AMENDMENT TO FACILITY OPERATING LICENSE

Amendment No. 32
License No. DPR-64

AMENDMENT TO FACILITY OPERATING LICENSE

Amendment No. 50
License No. DPR-59

FIGURE 6.2-1
MANAGEMENT ORGANIZATION CHART
INDIAN POINT 3 NUCLEAR POWER PLANT

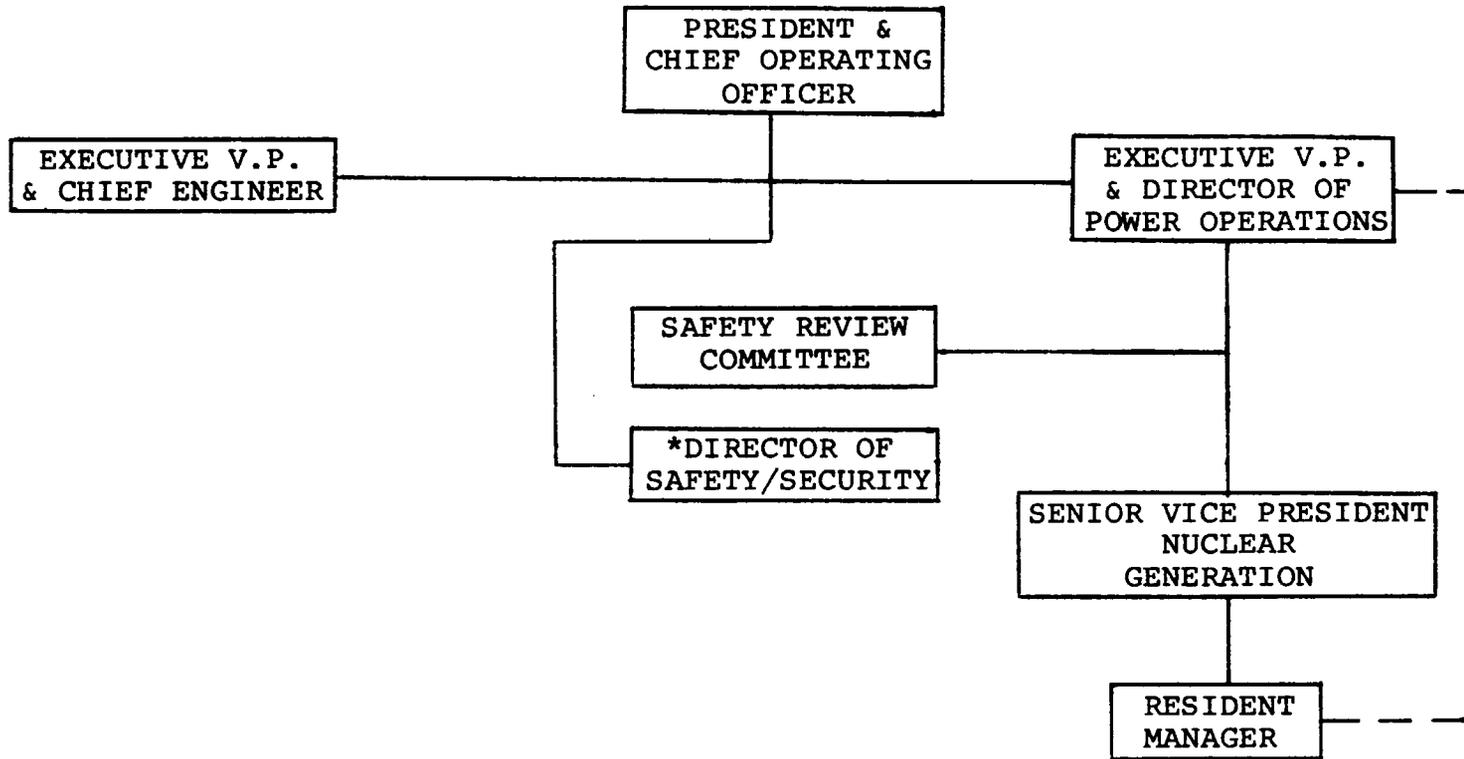
The proposed change to the organization chart has the Resident Managers reporting administratively to the Executive Vice President and Director of Operations instead of to the General Manager and Chief Engineer. Since the Executive Vice President and Director of Power Operations reports directly to the President and Chief Operating Officer, the proposed change will strengthen the licensee's management of nuclear operations. We, therefore, find this change acceptable. We also find acceptable changes in position titles.
